Proposal for amendment to ECE/TRANS/WP.29/GRSG/2024/12

Proposal for the 01 Series of Amendments to UN Regulation No. 166 (Vulnerable Road Users in Front and Side Close Proximity)

Submitted by the expert from Japan

Figure 1
Example for the measurement by maximum variation

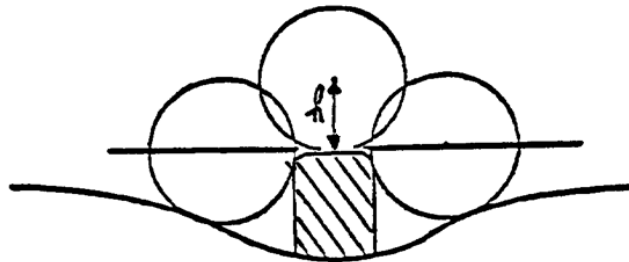
The addition of impact safety requirements for mirrors copied from UN Regulation No.46 which reflects the latest amendment (GRSG-126-24r1) and exempt the devices approved by UN Regulation No. 26 or No. 61.

6.1.3.3.2. If the dimension of the projection of a component which is mounted on a surface other than convex cannot be determined by simple measurement, it shall be determined by the maximum variation of the distance of the centre of a 100 mm diameter sphere from the nominal line of the panel when the sphere is moved over and is in constant contact with that component.

Figure 1 shows an example of the use of this procedure.

Figure 4

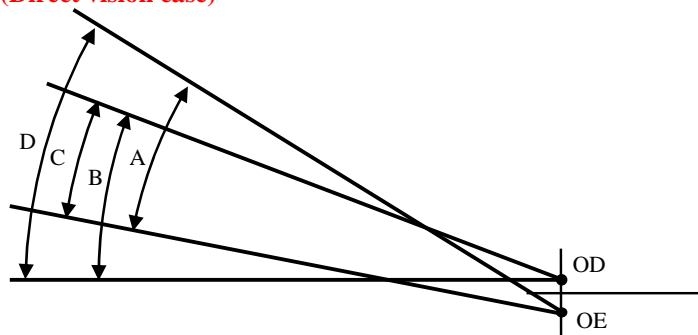
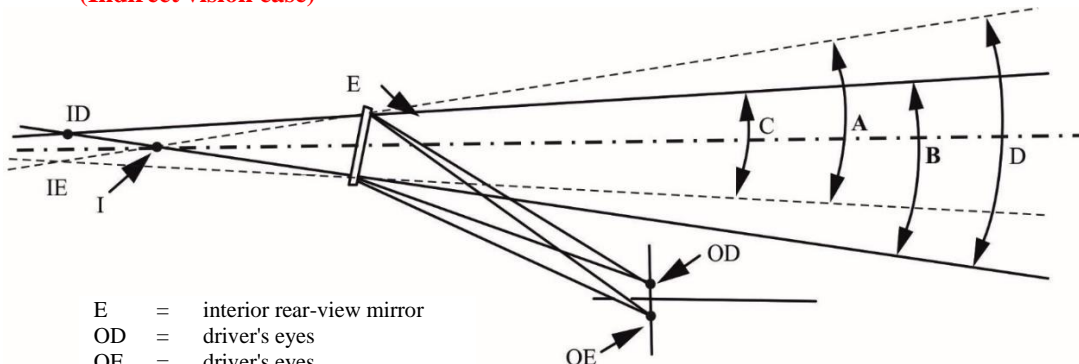
Paragraph 12.2. amend to read and Figure 1, renumber as Figure 4:

5. Paragraph 12.2:
Figure was copied from Regulation No.46. It was for indirect vision only. "Ambinocular vision" is for both direct and indirect vision. To prevent misinterpretation, direct vision case figure was added.

"12.2. "Ambinocular vision" means the total field of vision obtained by the superimposition of the monocular fields of the right eye and the left eye (see Figure 4 below).

Figure 5
Examples of Designated Area of Each Means (Right-Handed Drive Case)

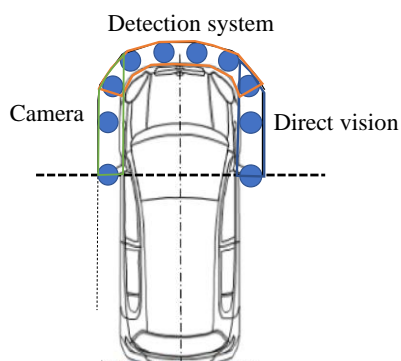
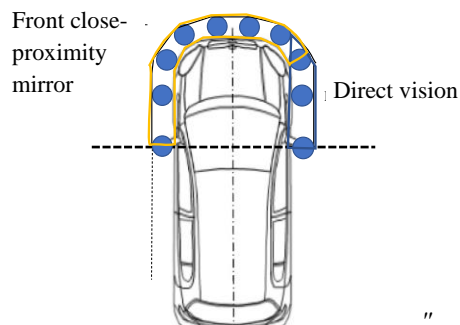
Overlaps of designated areas by different means (see examples in Figure 5) shall be permitted.

6. Paragraphs 15.1., 15.2. and 15.2.1.:
Reorganized between two paragraphs 15.1 and 15.2 for misunderstanding and for clear descriptions. The figures on pole location at the centre of the side mirror were updated to avoid misinterpretation.

The manufacturer shall declare to the technical service which means is used for which designated area, so that the technical service can set up the testing equipment accordingly. This shall be recorded in the test report.

Figure 6
Close-Proximity Front and Lateral Sides View Field of Vision

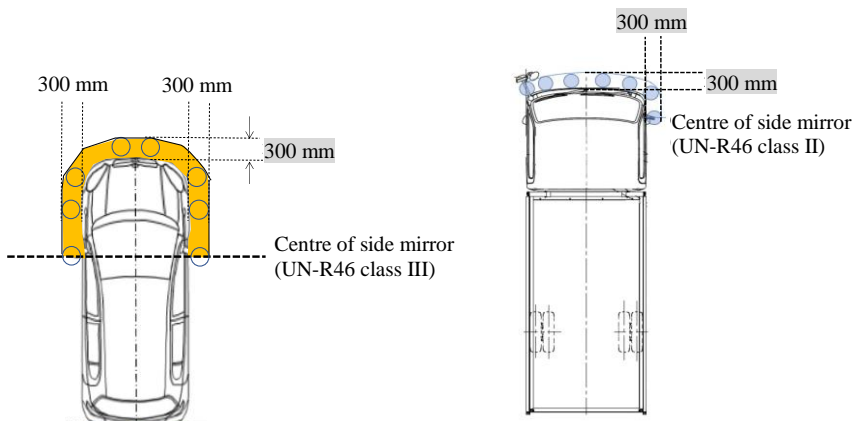
Paragraph 15.2., delete Figure 2 and amend to read:

The field of vision (see Figure 2 6 below) shall be bounded by the following planes:

- (a) A **longitudinal** ~~transverse~~ vertical plane passing through a point 300 mm from the contour of the sides of the vehicle;
- (b) A transverse **vertical** ~~horizontal~~ plane passing through a point 300 mm from the contour of the front of the vehicle;
- (c) Areas ahead of the centre of the side mirrors on the driver's seat side and the passenger seat side. In the case of the vehicle that equipped with CMS that comply UN Regulation No. 46, 04 Series of amendments, the manufacturer shall consider the same vehicle equipped with side mirrors or to use the centre of Class III or II CMS camera lens instead of the centre of the side mirrors.

The contour shall be defined by the vehicle outside shape projection to the ground that can place the test object defined in Annex 9 of this Regulation (300mm diameter pole). Small outside shape irregularity is not included.

Figure 7

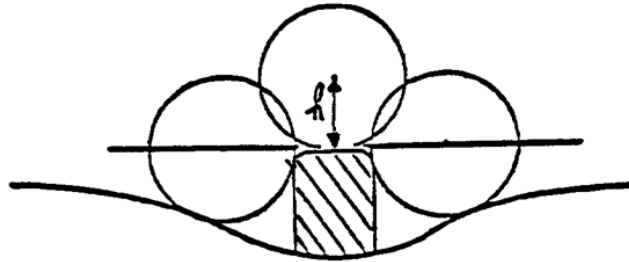
8. Paragraph 15.4.3.1~5.:
Addition of impact safety requirements for FLVCS and Detection system same concept as mirror (6.1.3.). These requirements are modified for consistency with CMS requirements of Regulation No.46 Paragraph 6.2.

- 15.4.3.2.2. If the dimension of the projection of a component which is mounted on a surface other than convex cannot be determined by simple measurement, it shall be determined by the maximum variation of the distance of the centre of a 100 mm diameter sphere from the nominal line of the panel when the sphere is moved over and is in constant contact with that component.

Figure 7 shows an example of the use of this procedure.

Figure 2
Test Object Locations

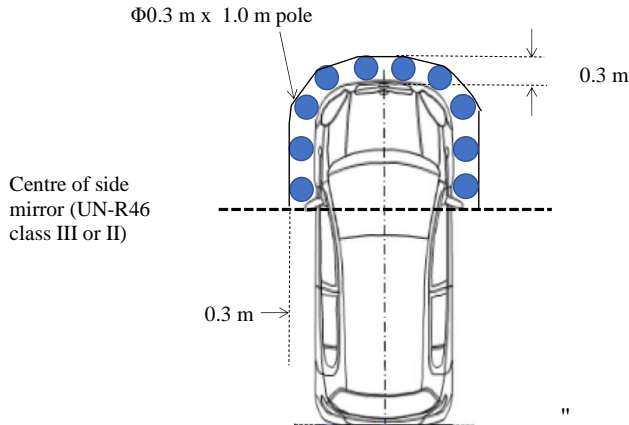
11. Annex 9:
Add the description for the Class II mirror in the figure.
 12. Annex 10:
Remove sentences for clarification
 13. Annex 13:
Reflects the latest amendment of UN Regulation No. 46 (GRSG-126-24r1).
-

- "1.2. The test object shall be in contact with the vehicle's front and lateral side from the

centre of passenger side mirror to driver's side mirror shall be seen in the close-proximity front and lateral view field of vision. In the case of the vehicle that equipped with CMS that comply UN Regulation No. 46, 04 Series of amendments, the manufacturer shall consider the same vehicle equipped with side mirrors or to use centres of Class III or II CMS camera lens instead of the centres of the side mirrors.
